**Edwin I. Hatch Nuclear Plant
Request for License Amendment
Extended Power Uprate Operation**

Page Change Instructions

The proposed changes to the Plant Hatch Unit 1 and Unit 2 Facility Operating Licenses and Technical Specifications are incorporated as follows:

**Facility Operating License Proposed Change
and
Technical Specifications Proposed Changes**

Figure 8-1-1: Pressure Test Curve (Curve A)

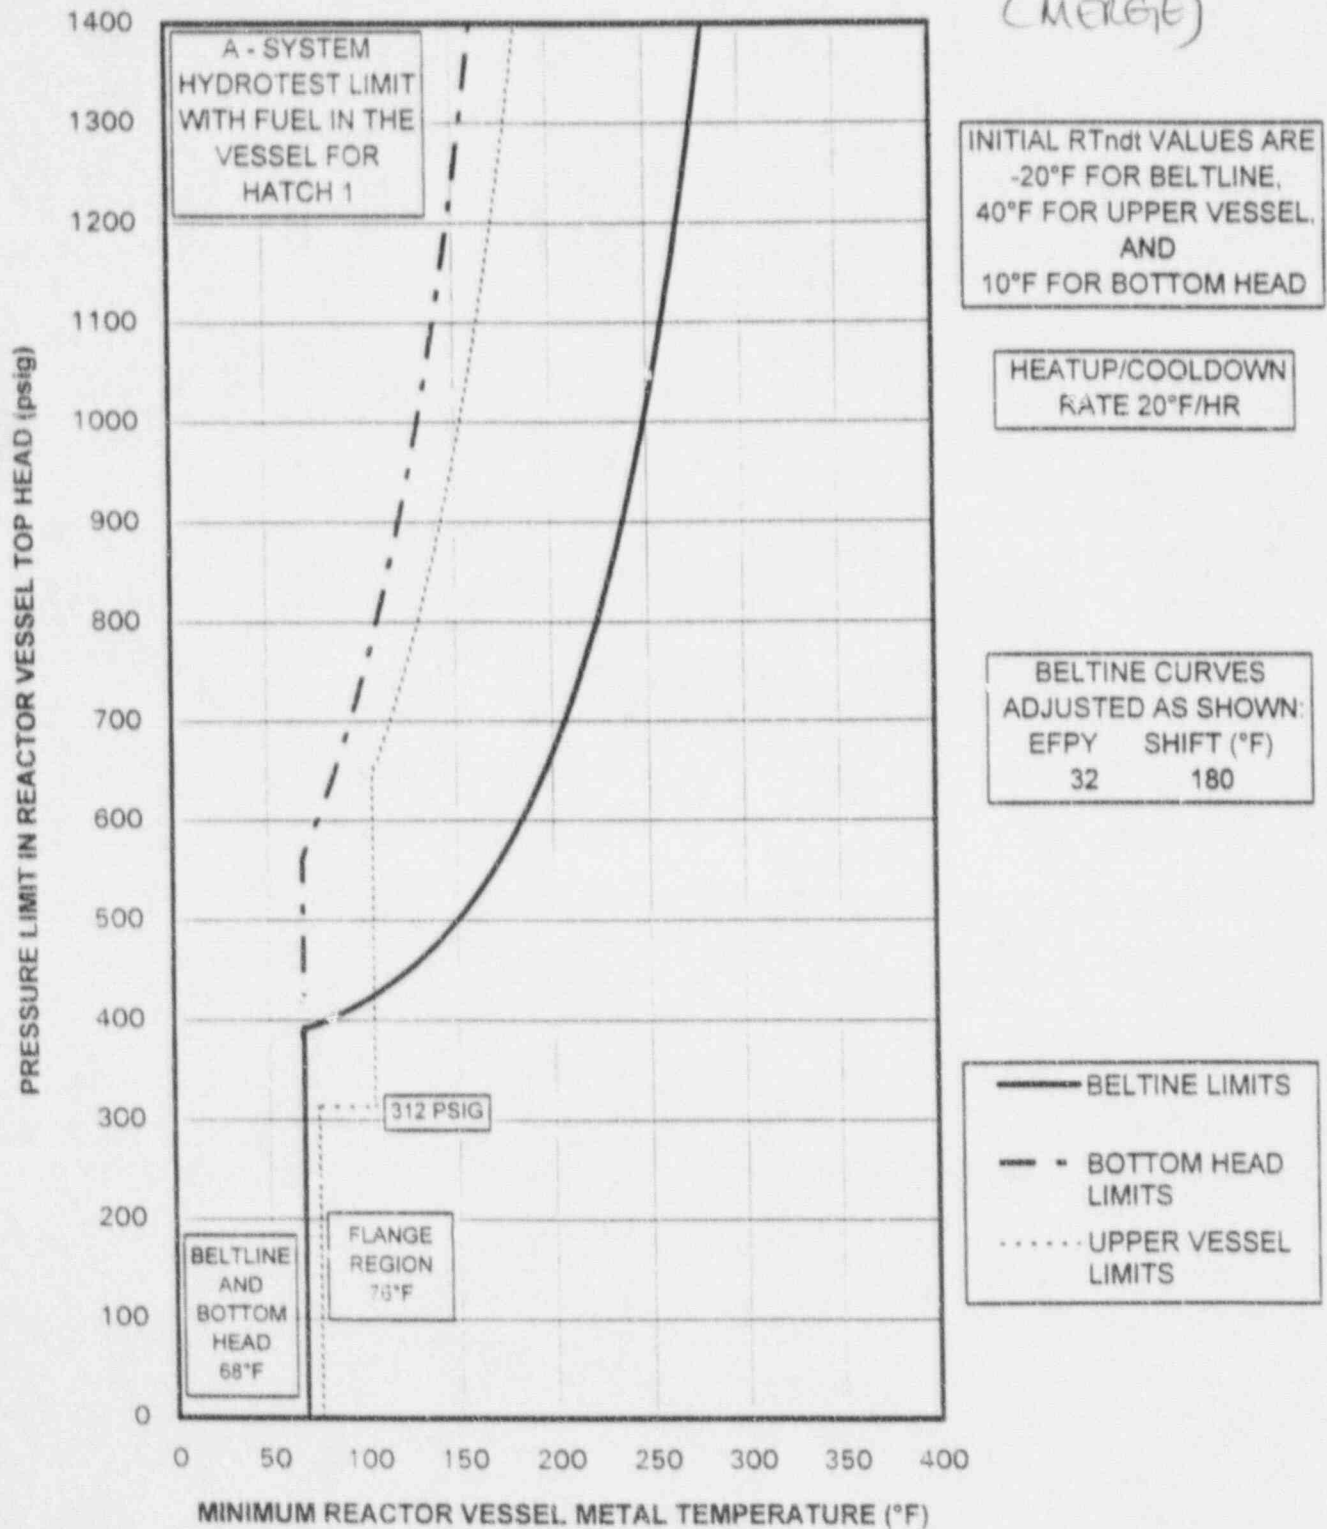
DELETE — SEE PROPOSED FIGURE ATTACHED

Proposed Figure

Figure 3.4.9-1 (Page 1 of 1)

Figure 3.4.9-2 (page 1 of 1)
Pressure/Temperature Limits for Non-Nuclear Heatup,
Low Power Physics Tests, and Cooldown Following a Shutdown

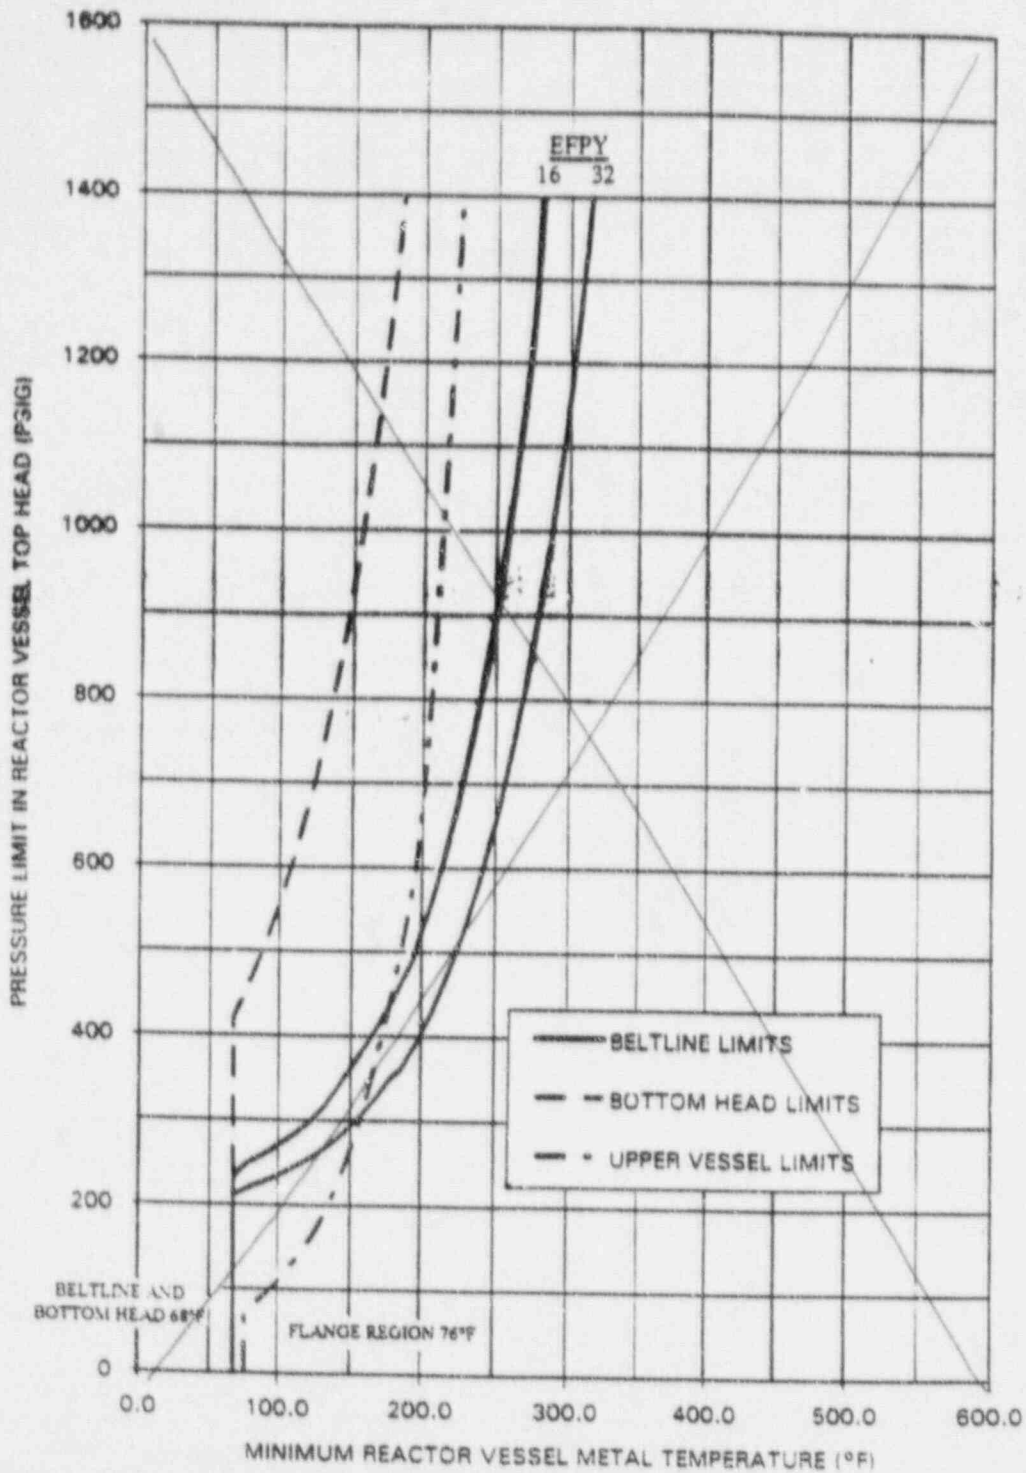
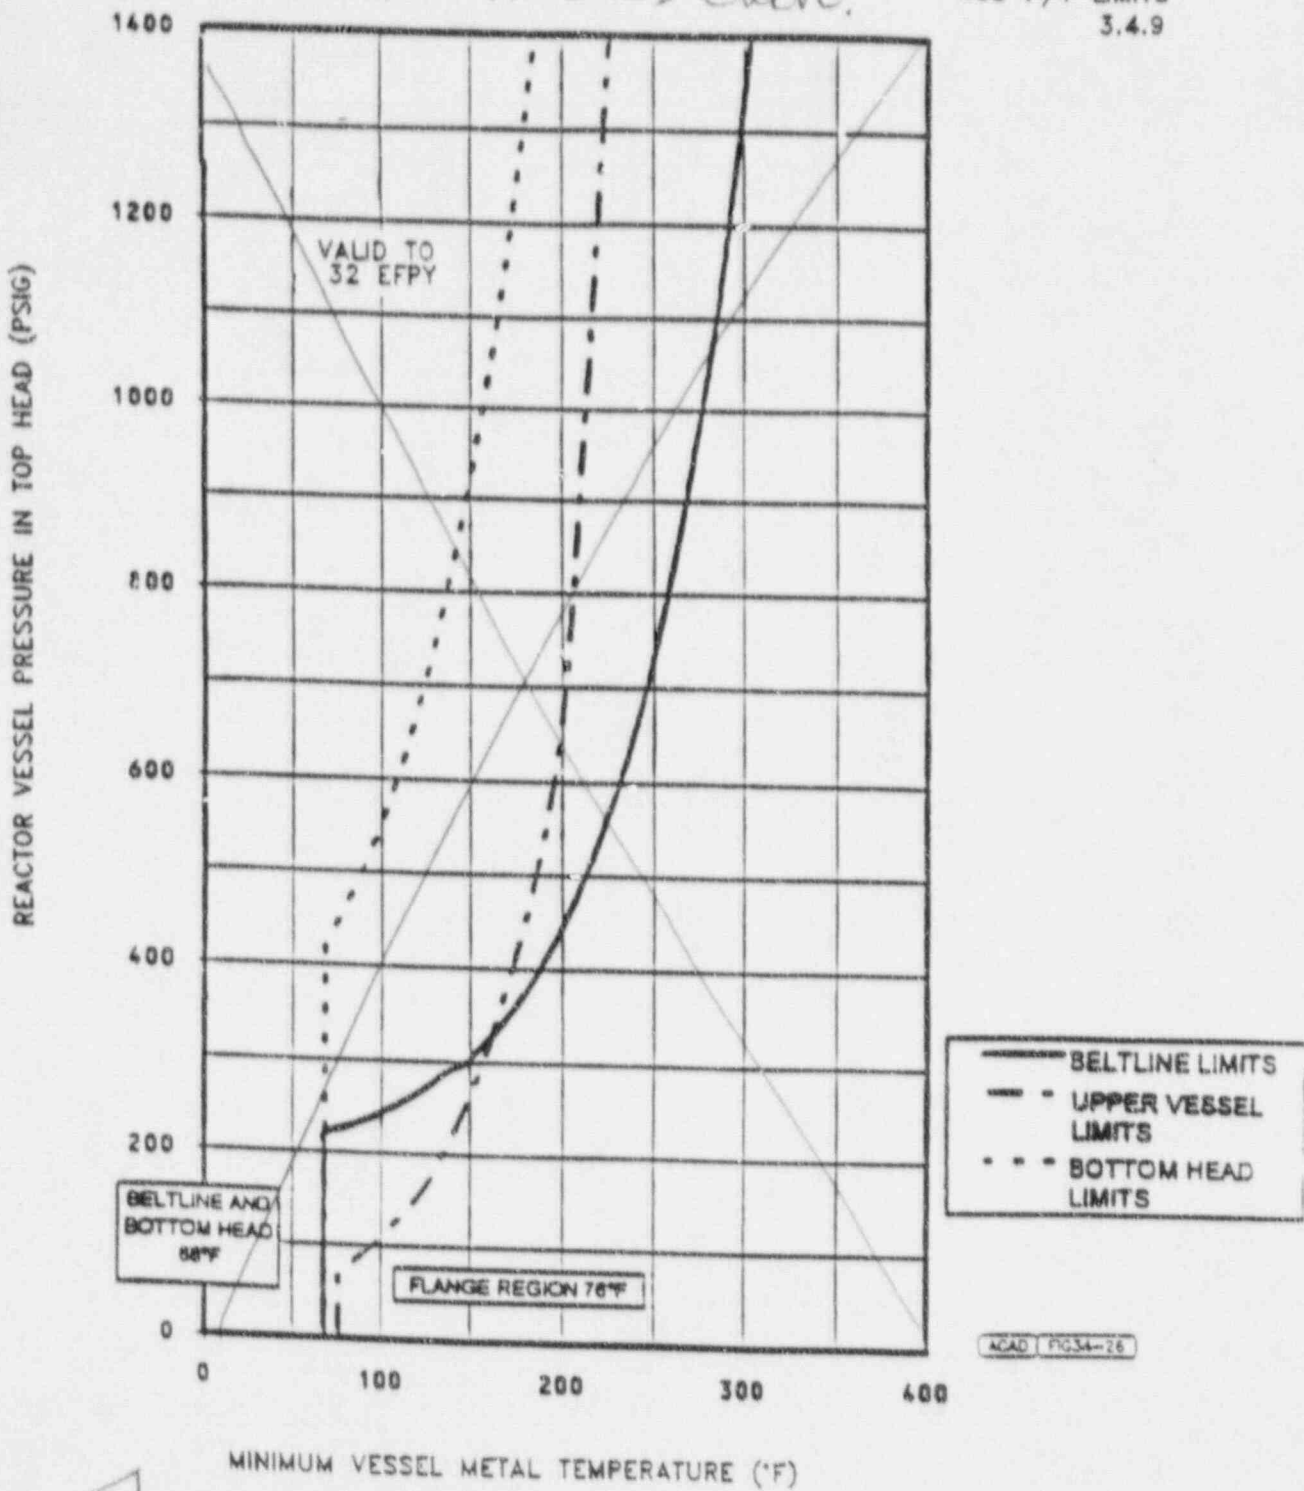
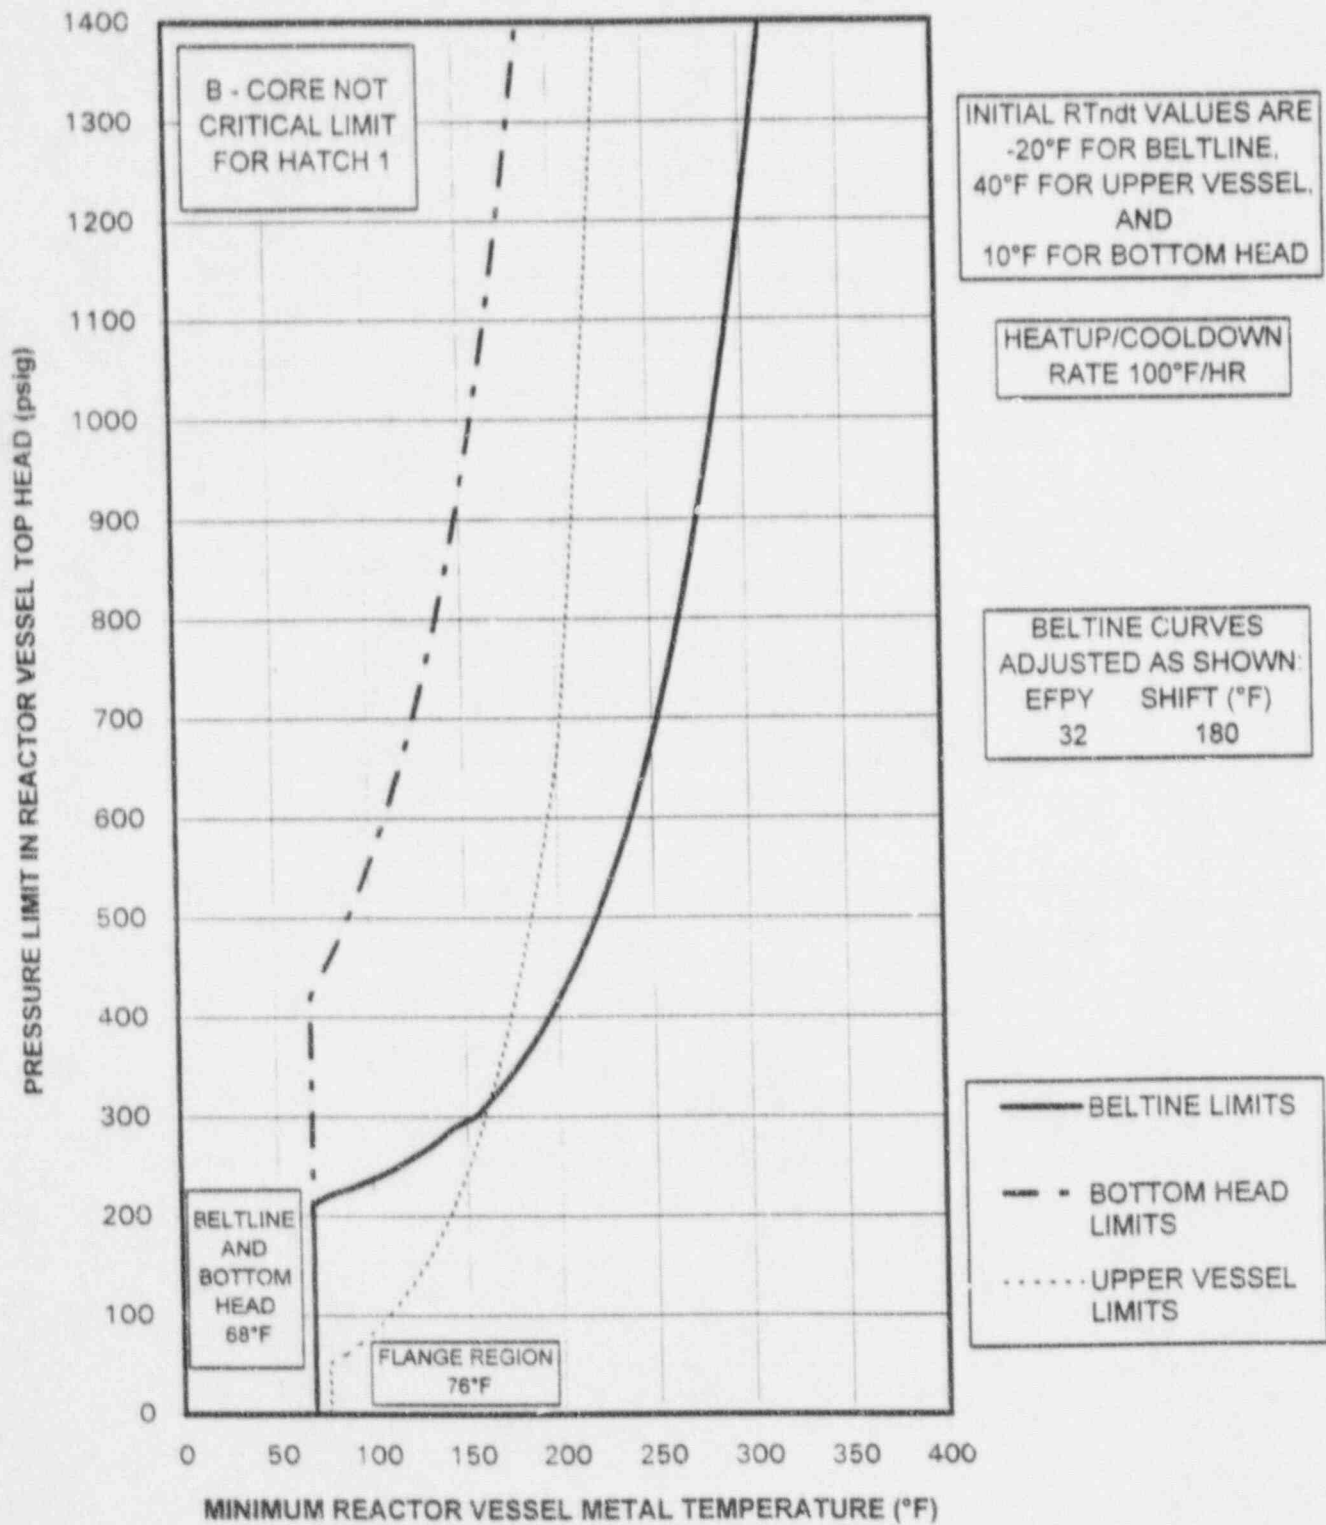
DELETE - SEE PROPOSED FIGURE ATTACHED.

REPLACE WITH ATTACHED CURVE.

PROPOSED FIGURE

Figure 3.4.9-2 (Page 1 of 1)
Pressure/Temperature Limits for Non-Nuclear Heat-up,
Low Power Physics Tests, and Cooldown Following a Shutdown
